**TESORO  
LOS ANGELES REFINERY  
INTEGRATION AND COMPLIANCE PROJECT  
FINAL  
ENVIRONMENTAL IMPACT REPORT**

VOLUME V: Appendix G (Comment Letter No. G1-75 – Response G1-78.166)

**Comment Letter No. G1-75**

FIGURE 76.2-1  
TESORO LOS ANGELES REFINERY  
MODELING GRID, SENSITIVE RECEPTORS, AND RISK ISOPLETH CONTOURS

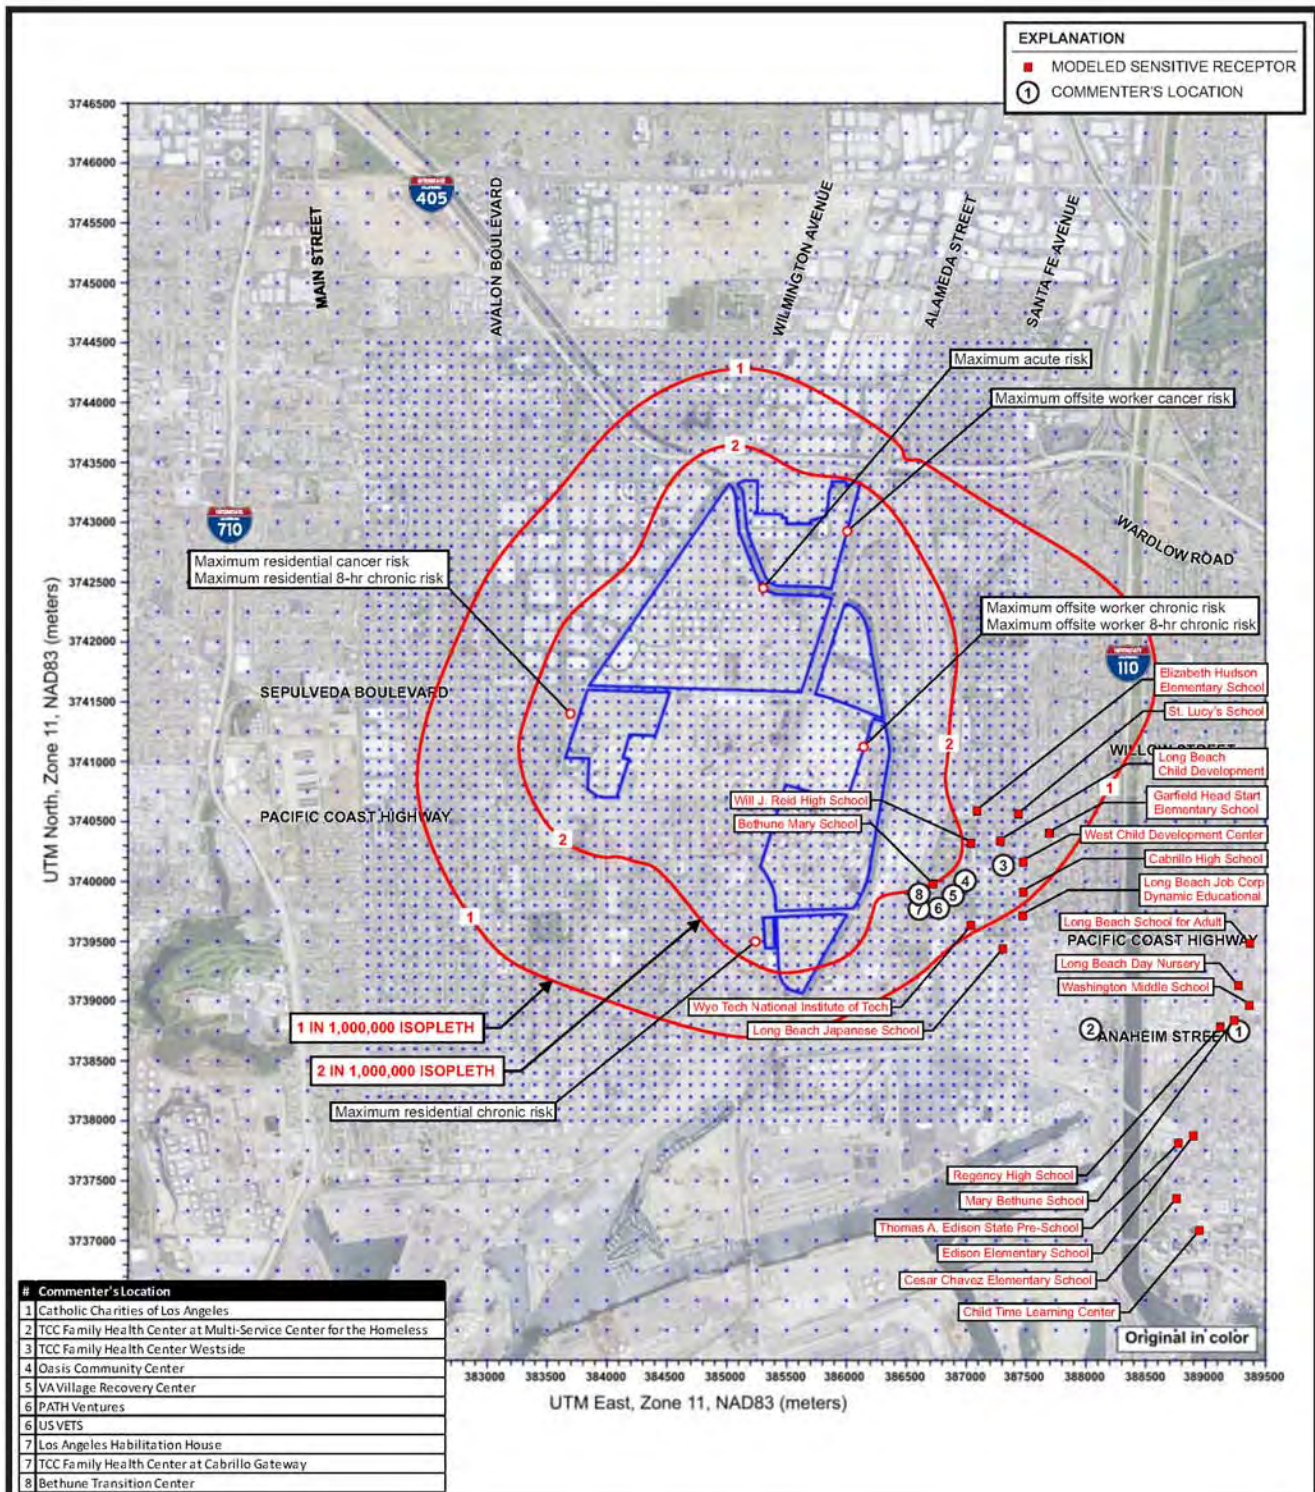
While Figure 1 of Appendix B-2 of the DEIR (page B-2-13), used the most recent 1981 USGS topographic map as the base map, the area labeled “U.S. Naval Reservation” was treated as a residential area in both the LST and HRA modeling. Residential and sensitive receptors, such as schools, are evaluated using the same criteria. The 76 individual sensitive receptors included in Table 6 in Appendix B-4 of the DEIR (pages B-4-25 and B-4-26) were compiled using a search of publicly available databases. While not all sensitive receptors listed in the comment are included in Table 6, the area where the sensitive receptors are located was evaluated as a residential area. The maximum carcinogenic risk for a residential location is west of the Refinery and the sensitive receptors listed in the comment are east of the Refinery.

As shown in Figure 76.2-1, the receptor grid used for both the HRA (DEIR page B-4-27) and the LST analysis (DEIR page B-3-279) encompass all valid receptors within 3,500 meters of the Refinery, and is a visual representation of all the receptors that were analyzed for LST and HRA. Valid receptors include all receptors not located in the Refinery or on roads and other transportation thoroughways. While all the sensitive receptors may not be directly named in the DEIR, all sensitive receptors within 3,500 meters of the Refinery were evaluated for LST analysis and HRA. As shown in Figure 76.2-1, sensitive receptors were included in the vicinity of the receptors mentioned in the comment.

**Figure 1.  
Mercaptans vs. API Gravity<sup>26</sup>**

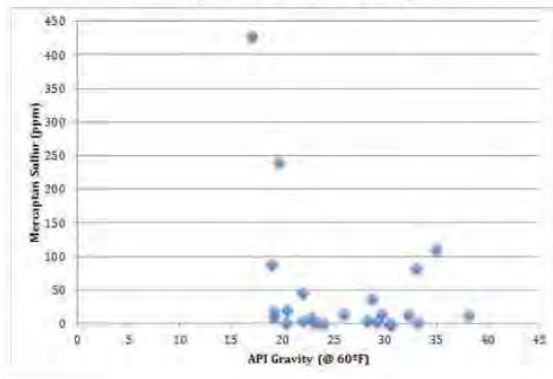
G1-78.113

**Figure 2.  
Mercaptans vs. Weight % Sulfur<sup>27</sup>**

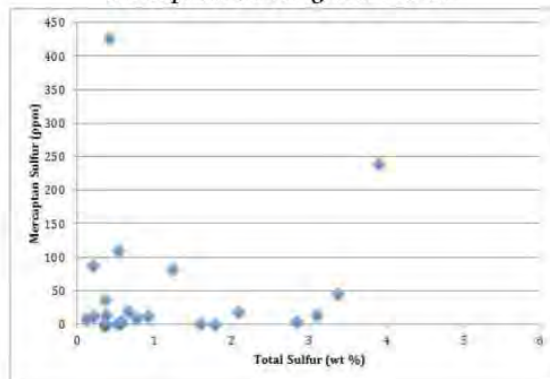
G1-78.113  
cont'd.

**Figure 3. Reid Vapor Pressure Compared to Total Sulfur and Density for 76 Different Types of Crude Oil<sup>29</sup>**

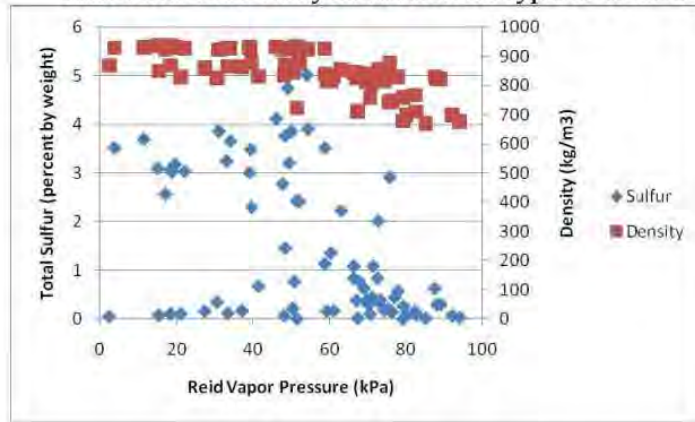
G1-78.114

Figure 5.  
Tesoro Cost-Advantaged Crude Strategy<sup>67</sup>  
West Coast Refining System Opportunity

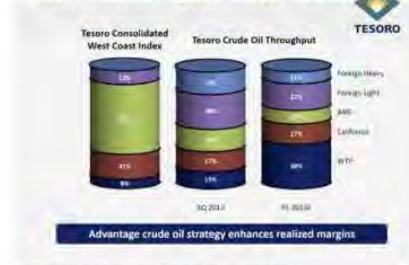
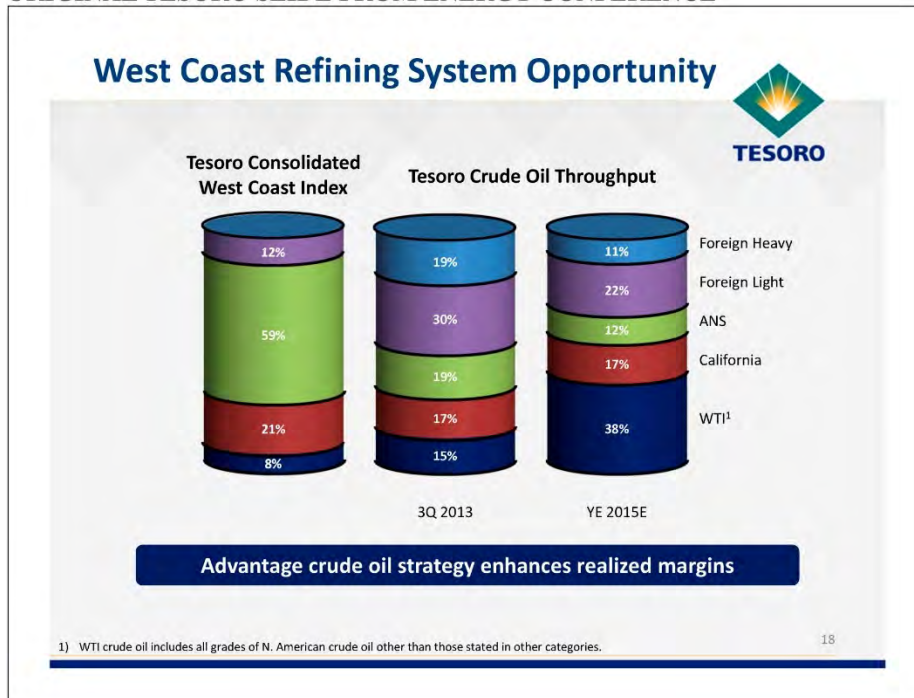
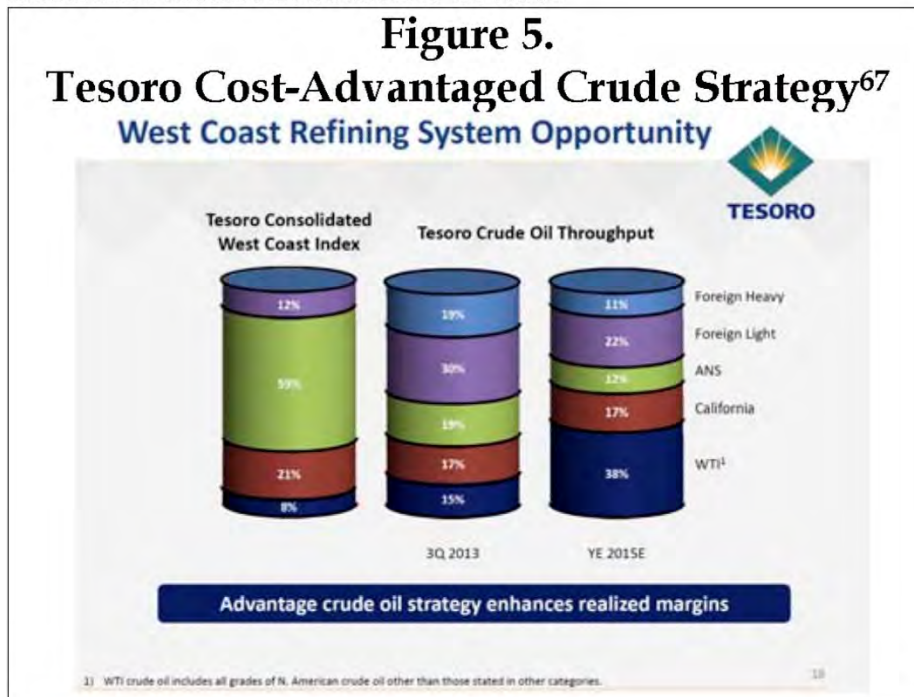
North American crudes, labeled “WTI,” which includes all grades of North American crude other than those identified in Figure 5.

The comment takes one slide from a presentation given by Tesoro at an energy conference, adds a new title and takes it out of context to support the contention that the vapor pressure used to calculate VOC storage tank emissions is consistent with corporate plans to replace the current crude oil slate with cost “advantaged crude oils”. However, the original slide from the presentation had nothing to do with vapor pressure (see Figure 78.132-1). Rather, it indicated in very general terms the possible changes in crude oils used throughout Tesoro’s West Coast refineries. The claims regarding vapor pressure in the comment are not supported by either the original slide, nor the slide retitled in the comment. As stated in the DEIR at page 2-16, in 2014 alone, the Refinery processed over 30 different crude oils with varying vapor pressures. The vapor pressure used to calculate VOC emissions in the DEIR was based upon the vapor pressure of the crude oil with the highest emissions, so as to estimate a worst case scenario.<sup>149</sup>

Figure 6.  
Bakken Crude Yields More Gasoline and Distillate and Provides Higher Margins<sup>85</sup>

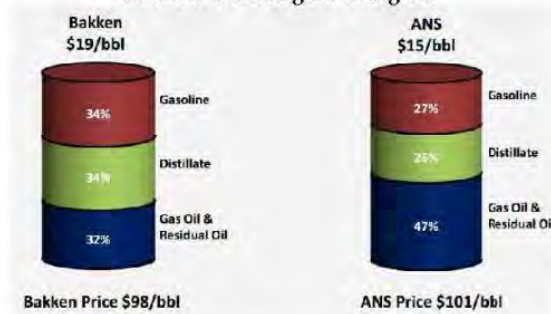
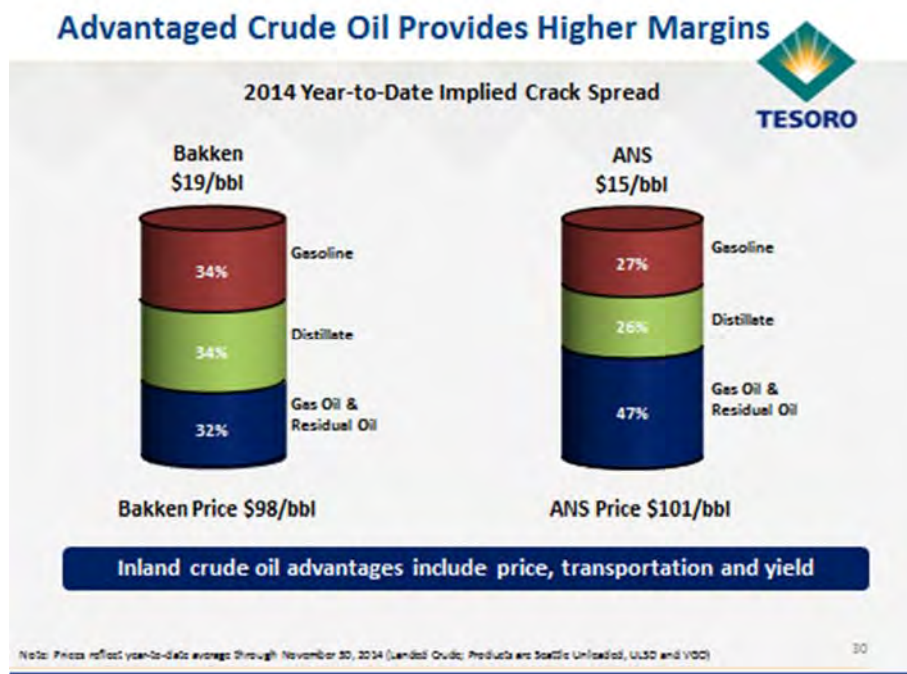
G1-78.136

Figure 9.<sup>178</sup>  
RVP Frequency for Bakken Crudes

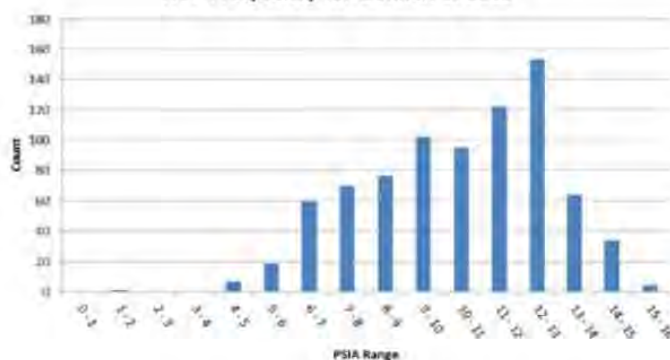
G1-78.160
